Notice of Meeting for the Historic and Architectural Review Commission of the City of Georgetown February 25, 2021 at 6:00 PM at Virtual

Meeting Date: *February 25, 2021*File Number: 2020-30-COA

Project Name: First United Methodist Church HVAC and Sanctuary Renovation

Meeting Date: *February 25, 2021*File Number: 2021-1-COA

410 E. University – Proposed Door Location

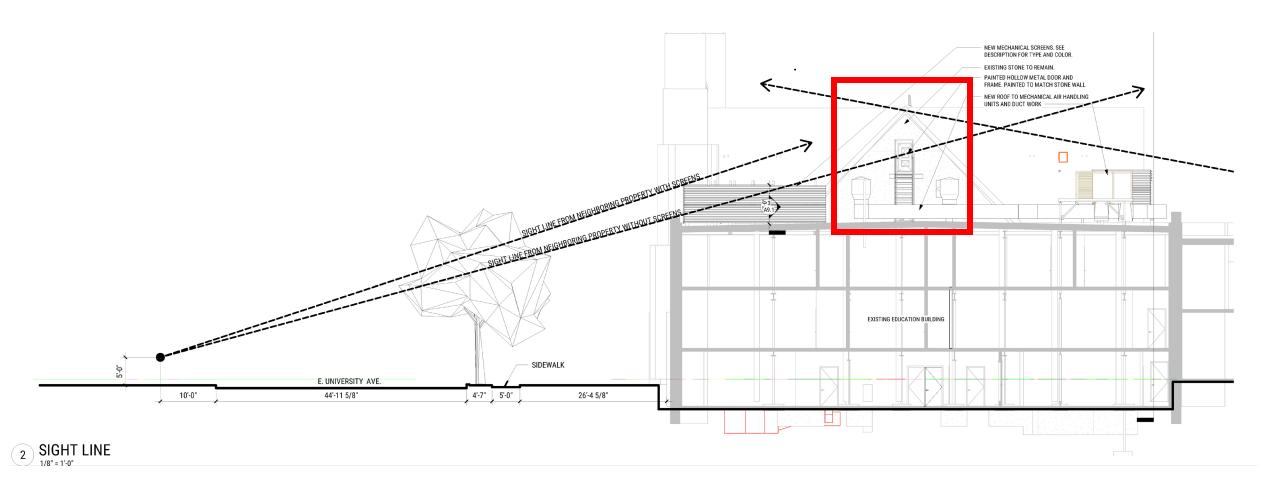
The proposed access door installation has minimal visibility from the street as it is to be installed in a portion of the west building façade that is partially obscured by later additions to the west side of the original historic sanctuary building. Additionally, HARC previously approved the installation of an outdoor air louver in the same location. The access door has a similar size to the louver but a different orientation, and the top of the door opening will sit higher on the façade than the louver would have.

208 S. Austin Proposed Porch & Deck (Rear View)

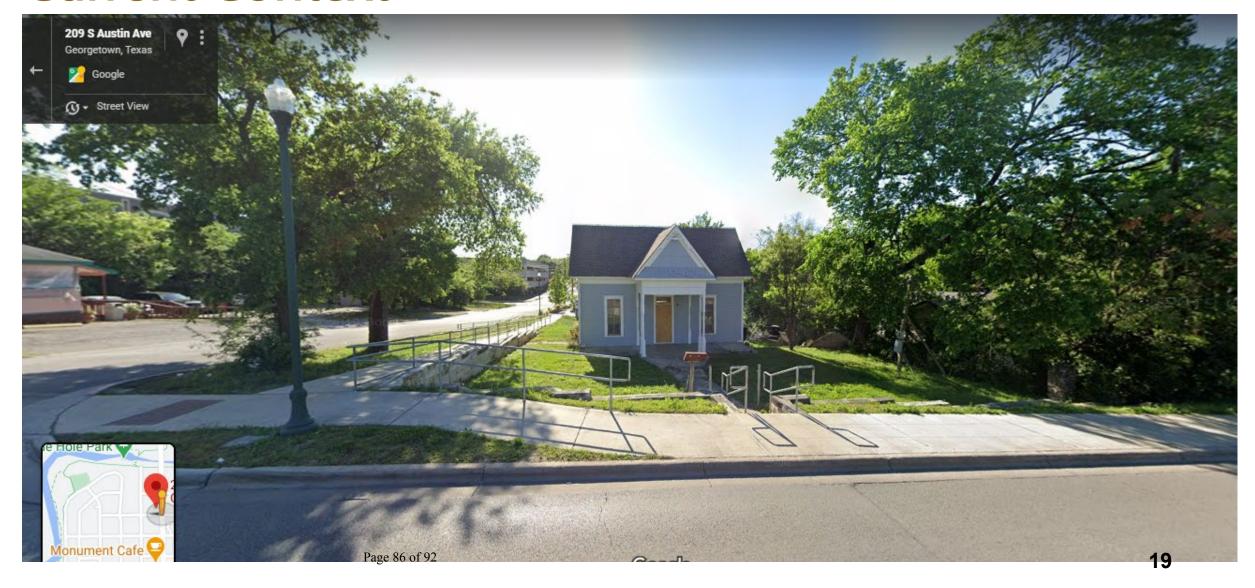
The Applicant is requesting HARC approval for the addition of a rear wood deck and patio, which would be part of the W. 3rd Street façade. The deck and patio are proposed to have wood screening elements on the west façade, with a style similar to a contemporary pergola.
